ORIGINATION FORM

Proposed Revisions to a Standard Plans Index
(Please provide all information – Incomplete forms will be returned)

Index Number: 455-030
Sheet Number (s): 1
Index Title: 30" Square Prestressed Concrete Pile

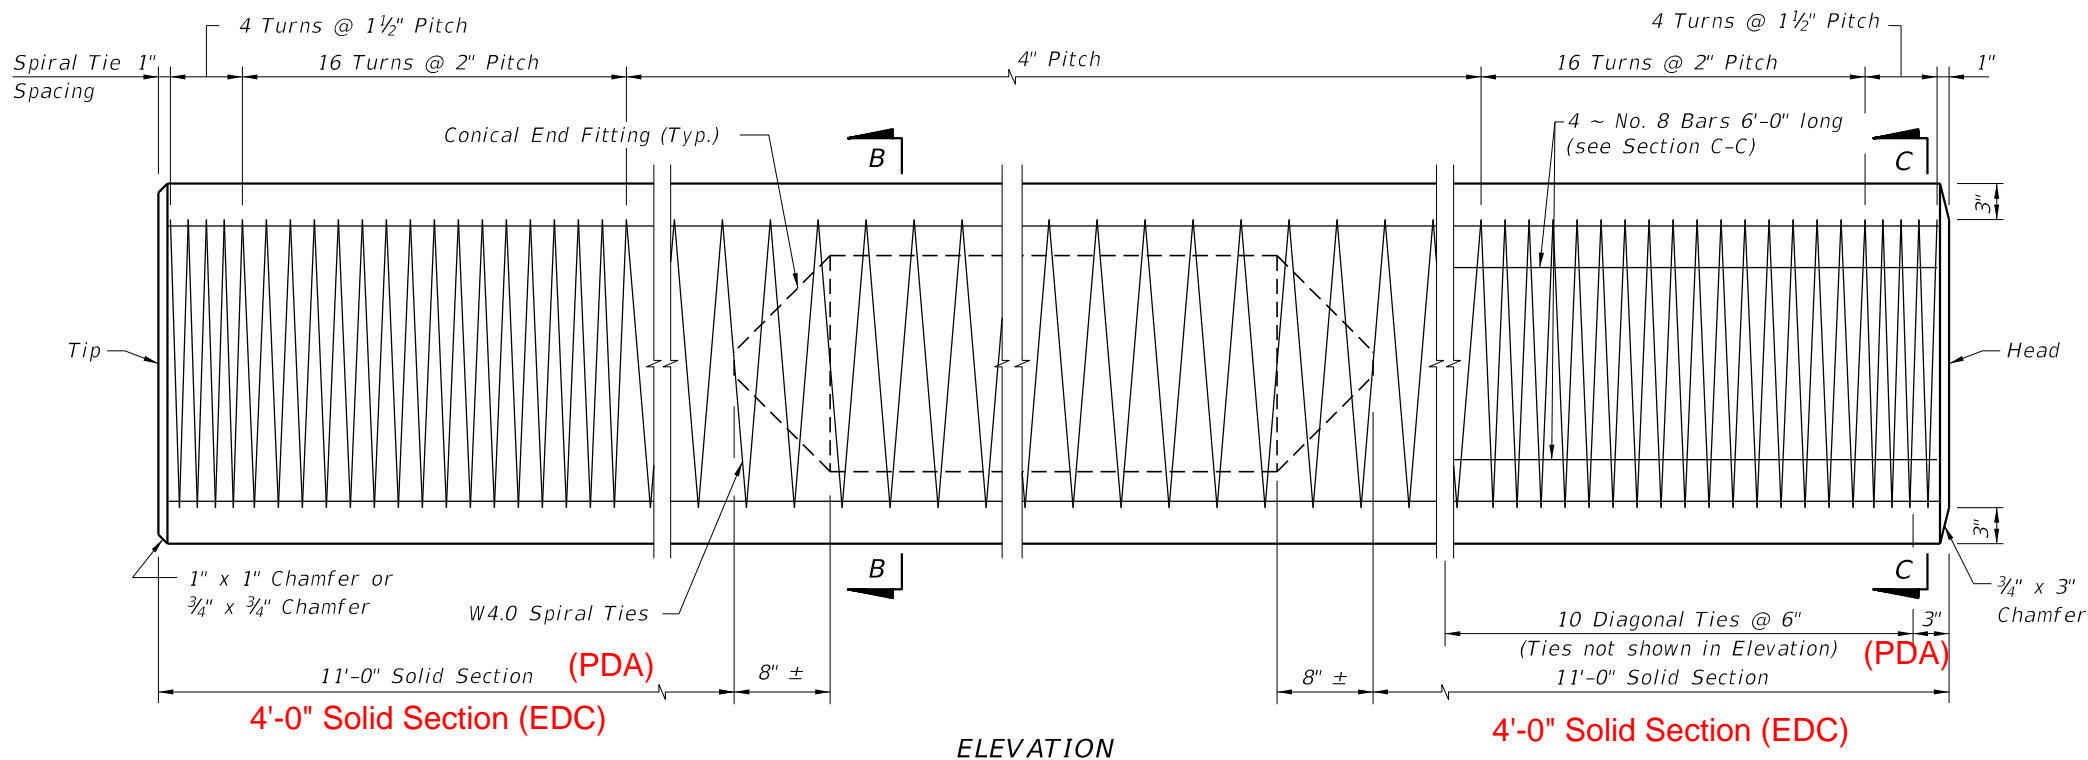
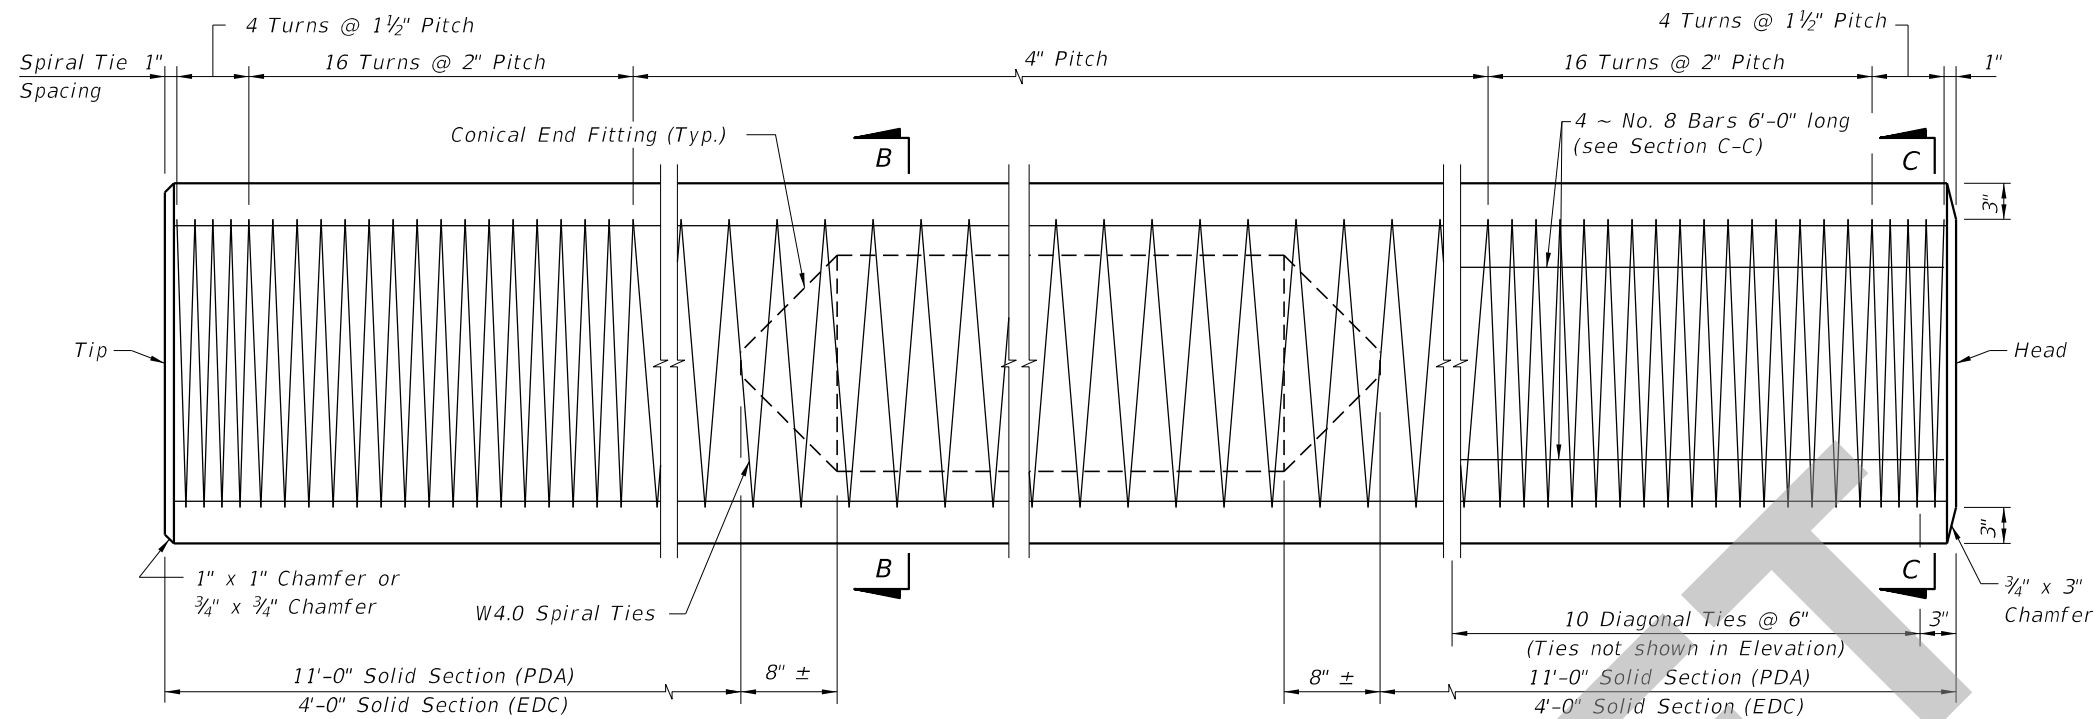
Added void length dimension for EDC

Double dimensioned void length for PDA & EDC
